UNITED STATES PATENT AND TRADEMARK OFFICE

APPLICATION NO.	FILING DATE	FIRST NAMED INVENTOR	ATTORNEY DOCKET NO.	CONFIRMATION NO.
10/542,441	07/15/2005	Yaogang Chen	3410-0108PUS1	2781
2292 7590 01/23/2009 BIRCH STEWART KOLASCH & BIRCH PO BOX 747 FALLS CHURCH, VA 22040-0747				
EXAMINER IEVA, NICHOLAS				
ART UNIT 2836		PAPER NUMBER		
NOTIFICATION DATE 01/23/2009		DELIVERY MODE ELECTRONIC

Office Action Summary

DETAILED ACTION

Figure A

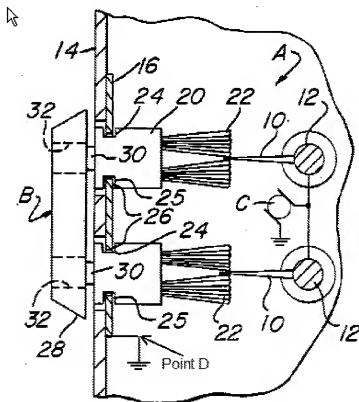
Consider **claim 12**, Rodrigo et al. teaches a generator, comprising a casing **14**, said casing having conductive protecting grille **16**, the conductive protecting grille is connected to a certain potential (ground); an interior circuit **C** within the casing; an ion emitting head (**12 and 10**) attached to the interior circuit; and a discharge resistance (resistance of wire between point D and ground), the discharge resistance is connected to the conductive protecting grille by a wire (the wire between the grill and point D) (Rodrigo; figures 1 and 2; column 2, line 60 – column 3, line 20; column 3, lines 54-67; and Figure A, below).

Consider **claim 14**, Rodrigo et al. teaches a generator, comprising a casing **14**, said casing having conductive protecting grille **16**, the conductive protecting grille is connected to a certain potential (ground); an interior circuit **C** within the casing; an ion emitting head (**12 and 10**) attached to the interior circuit and means for maintaining the potential of the conductive protecting grille (the resistance of wire between point D and ground) (Rodrigo; figures 1 and 2; column 2, line 60 – column 3, line 20; column 3, lines 54-67; and Figure A, above).

Consider **claim 15**, Rodrigo et al. teaches that the means for maintaining the potential of the conductive protecting grille is a discharge resistance (the resistance of wire between point D and ground) in the casing and is electrically connected to the conductive protecting grille via the wire between the grill and point D (Rodrigo; figures 1 and 2; and Figure A, above).

Rodrigo et al. teaches a conducting protective grille **16** that is connected to a certain potential (ground) and a discharge resistance (resistance of wire between point D and ground) that is spaced from said conducting protective grille via the wire between the grill and point D (Rodrigo; figures 1 and 2; column 2, line 60 – column 3, line 20; column 3, lines 54-67; and Figure A, above).

Consider **claim 11**, Rodrigo et al. teaches that the discharge resistance (resistance of wire between point D and ground) is connected to the conducting protective grille by a wire (the wire between the grille and point D) (Rodrigo; figures 1 and 2; and Figure A, above).
